10.9.20

Addendum to the AIA report by Koala Arbor Consulting Arborists regarding 56 Beane St, Gosford, NSW (dated 26/02/2020).

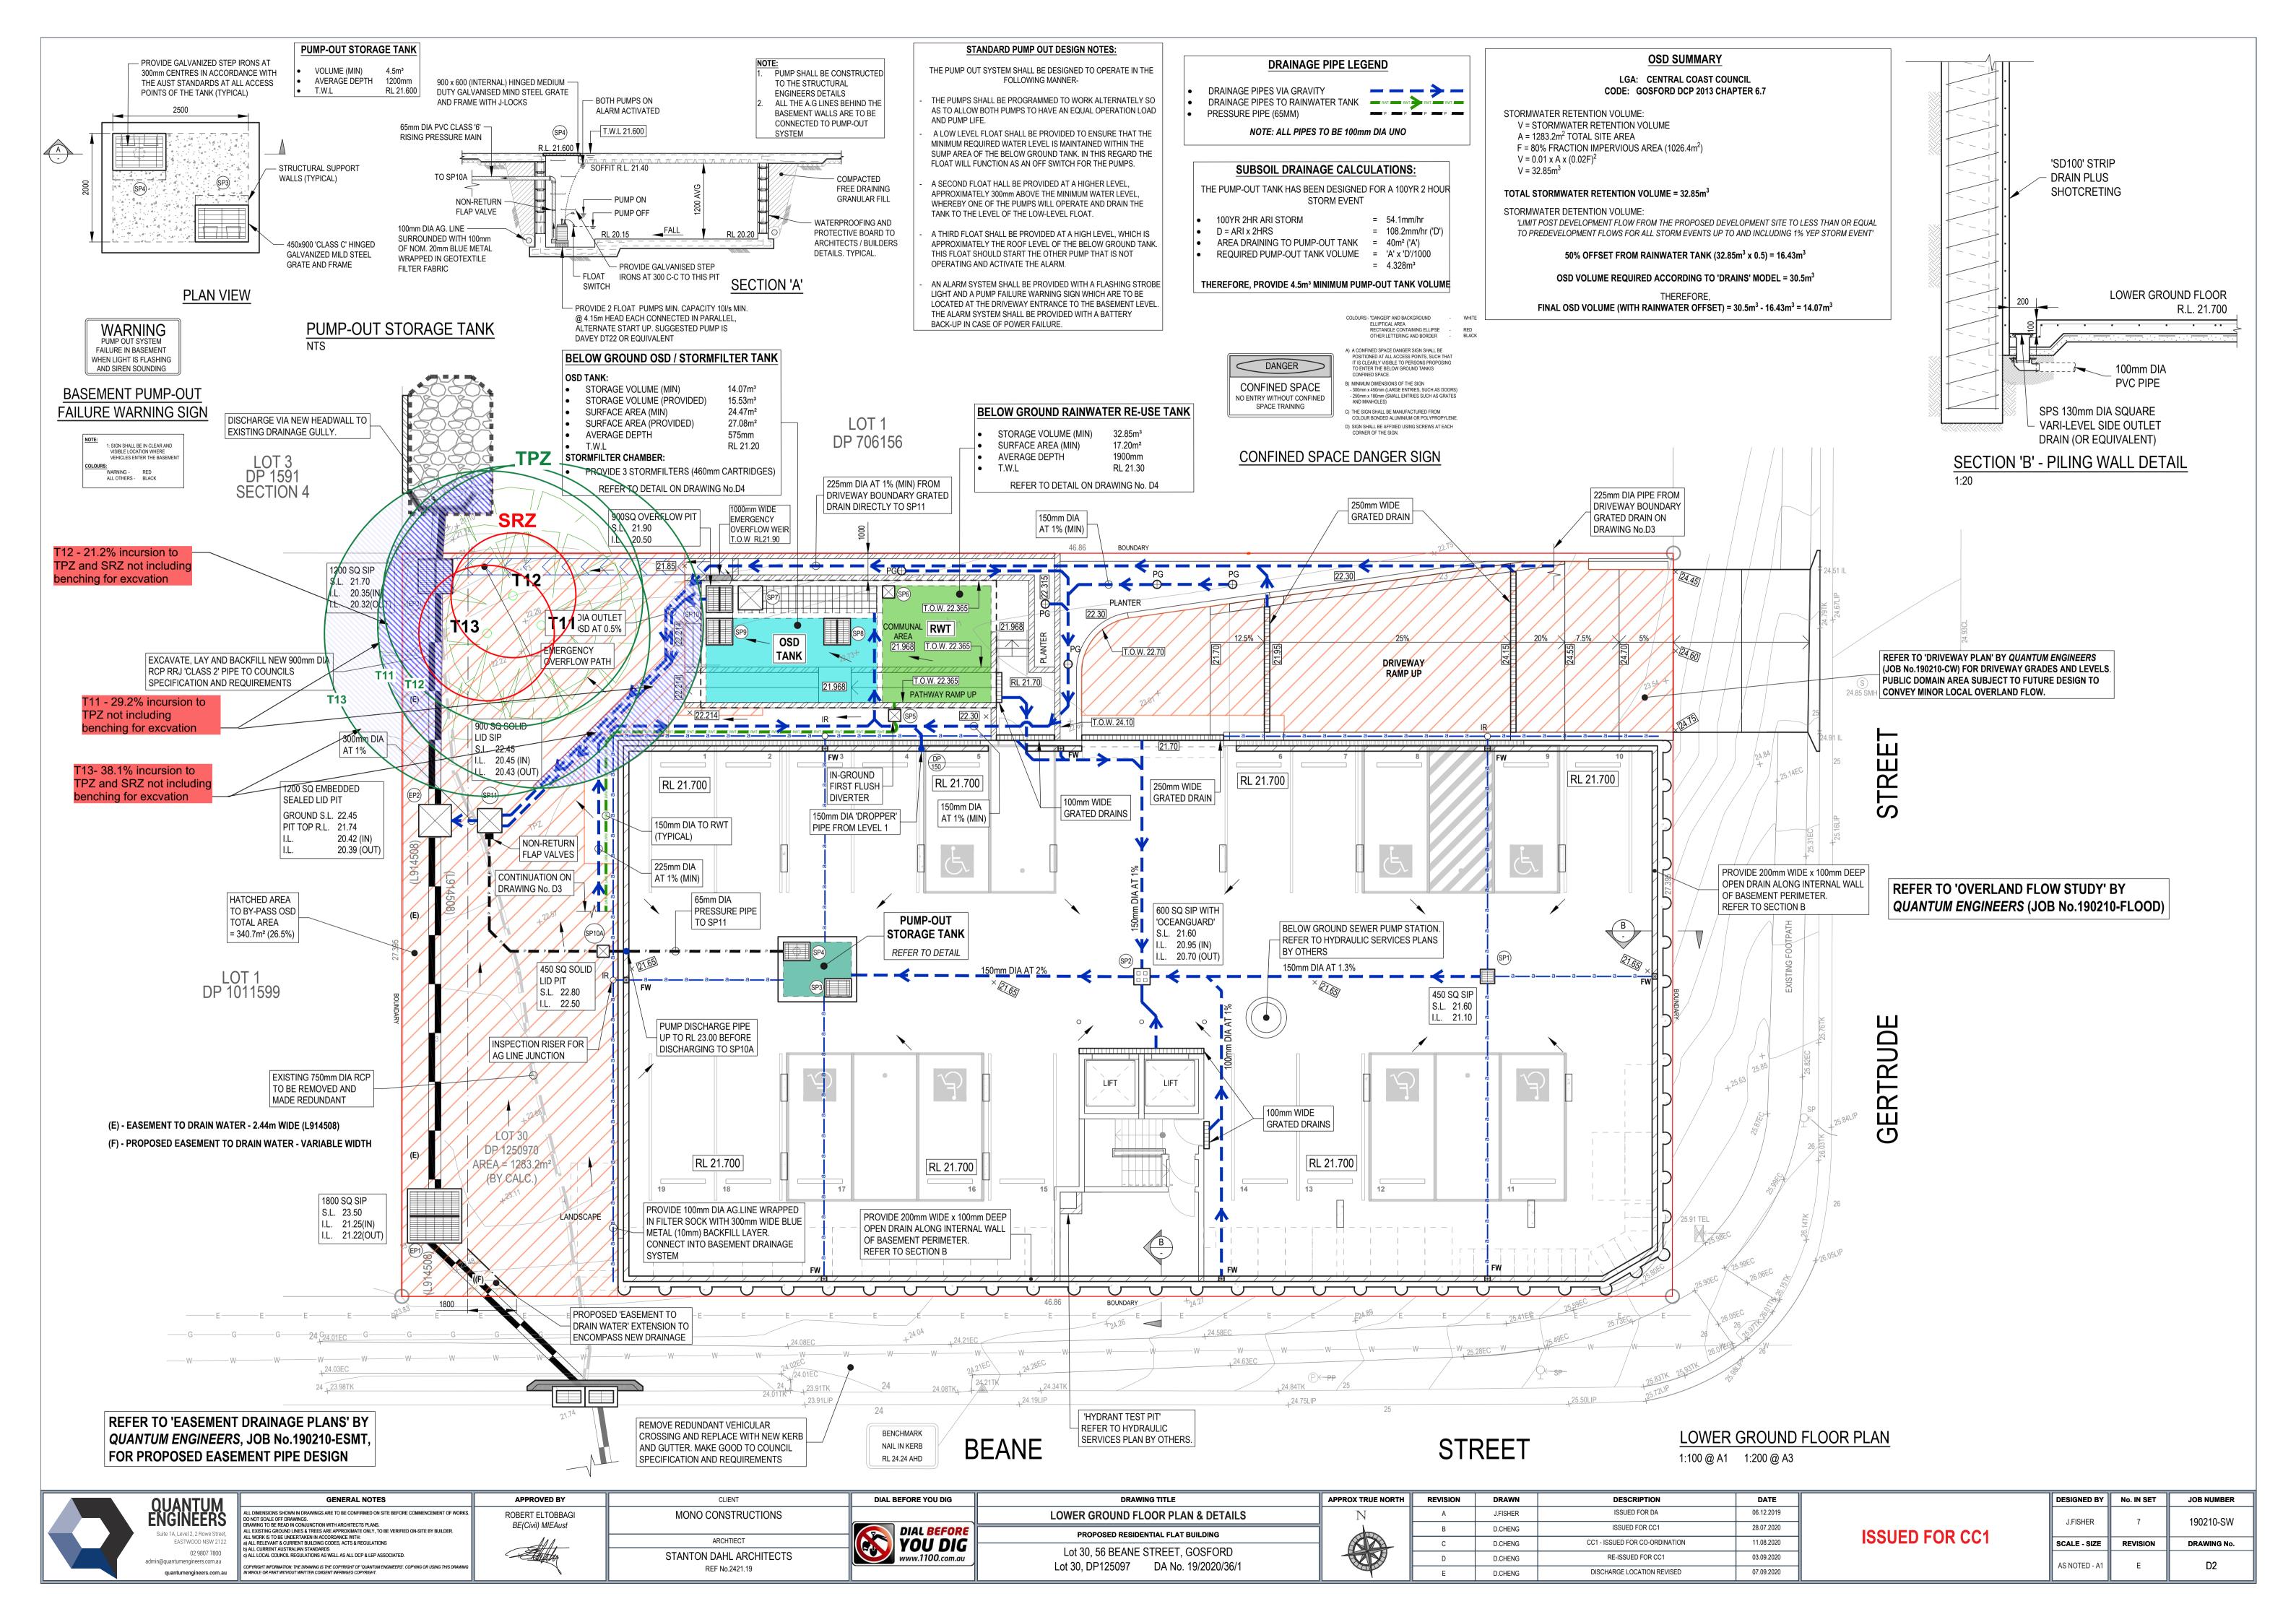
Applying the previously outlined Aim and Methodology a further review of required stormwater drain as per the drawings attached will impact a total of three additional trees (No. 11, 12 and 13). These trees will require removal due to major incursions to each TPZ and in some cases SRZ. The incursion results from a 900mmø storm water pipe, storm water pits, additional 225mmø storm water pipes and a drainage gully.

- Tree 11 has a 29.2% incursion.
- Tree 12 has a 21.2% incursion including the SRZ.
- Tree 13 has a 38.1% incursion including the SRZ.

Please see the drawing below for more information regarding the incursion to each tree.

on the 10.9.20 the replanting of three smaller to medium sized native trees along the western side of the site can be jointly recommended to offset the loss of trees on the site. This is the maximum number of trees that can be successfully established given the constraints of infrastructure and land size on site. Please note in clause B.6 of a section 4.16 in relation to DA 10132, trees 15 and 16 are to be replaced as per the above if there removal is required.

As such, the species to replanted should be *Harpullia pendula* - Tulipwood as per the land-scape plan provided by Site Image Landscape Architects.
